**ALL INDIA INSTITUTE OF MEDICAL SCIENCES,
ANSARI NAGAR, NEW DELHI**

AMENDMENT No. – I

Project Name: Construction of Mother & Child Block Including Associated Works, Operation & Maintenance during defect liability period at Masjid Moth Area, Ansari Nagar, New Delhi for AIIMS, New Delhi

Reply to Pre Bid Queries raised by bidders during pre -bid meeting held on 13.06.2014 at HSCC, Head Office, Noida

MOTHER AND CHILD BLOCK

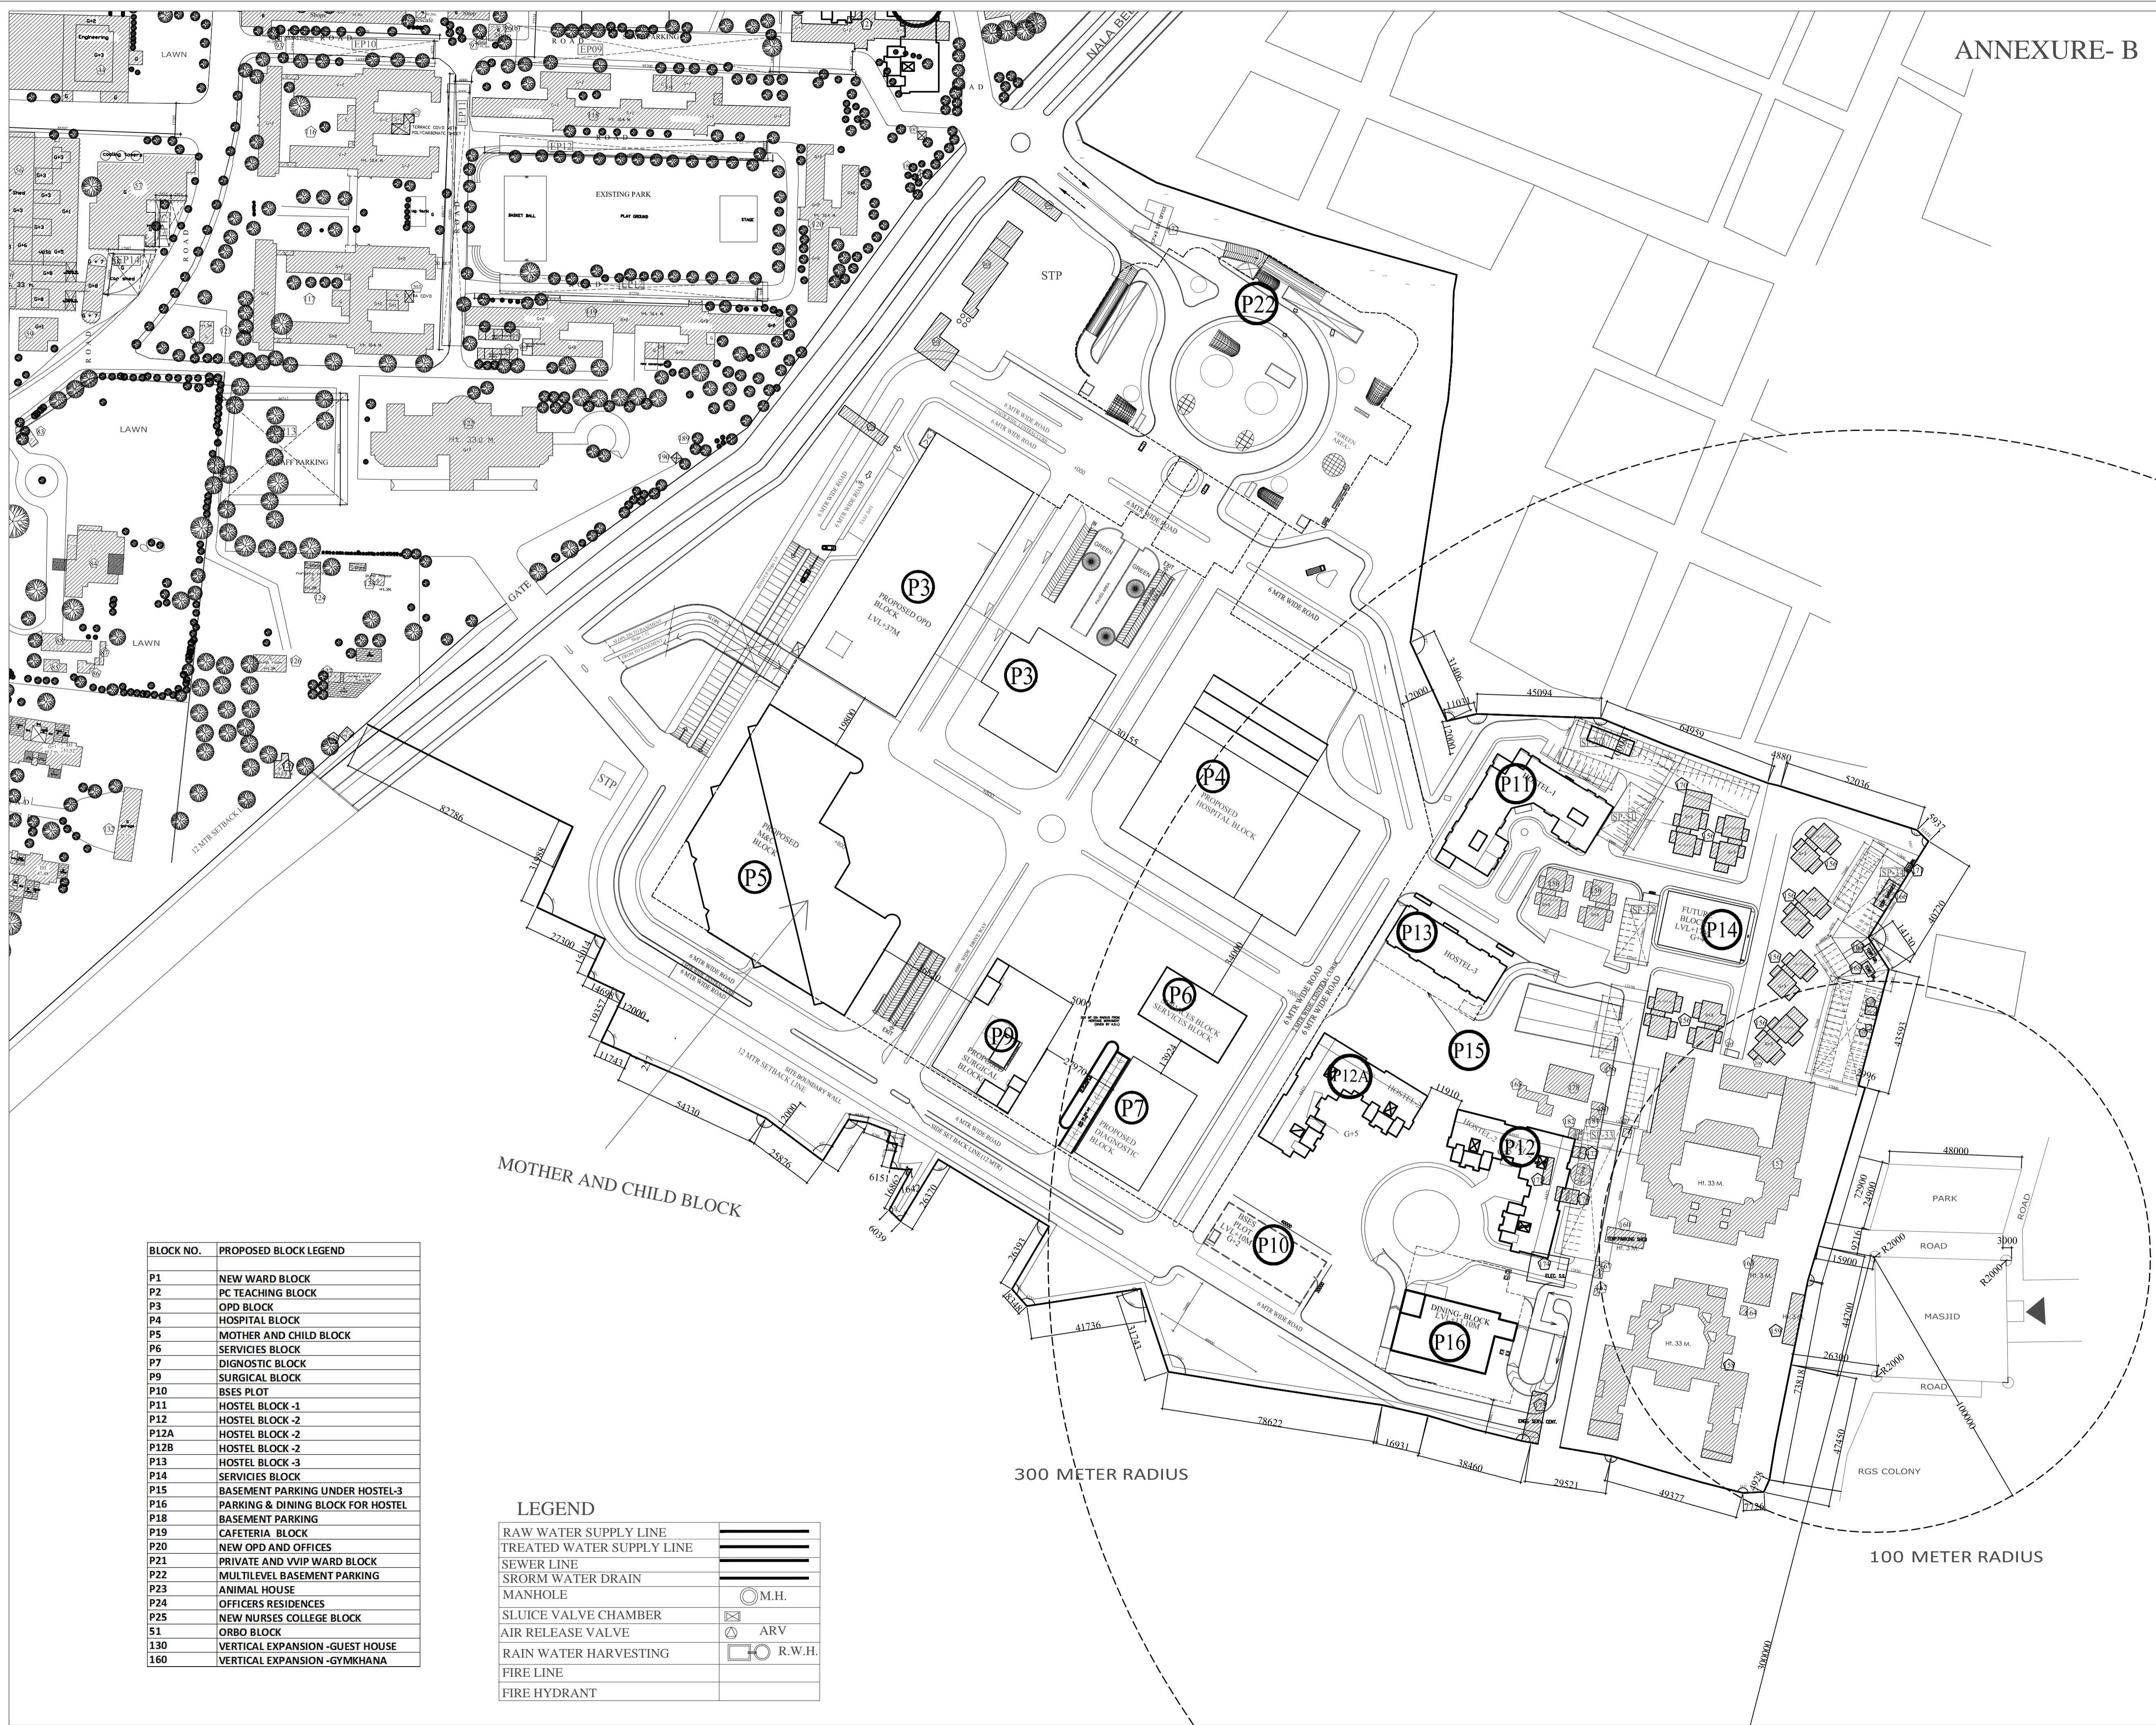
37.	General	Request you to provide the Master Layout Plan - Earmarking the proposed Buildings in order to plan the temporary facilities like batching plant, Labour colony , steel yard etc.,	Site layout plan has been uploaded at Annexure-B, which indicate the location of Mother & Child block for which tender has been called. For other queries please refer tender conditions.
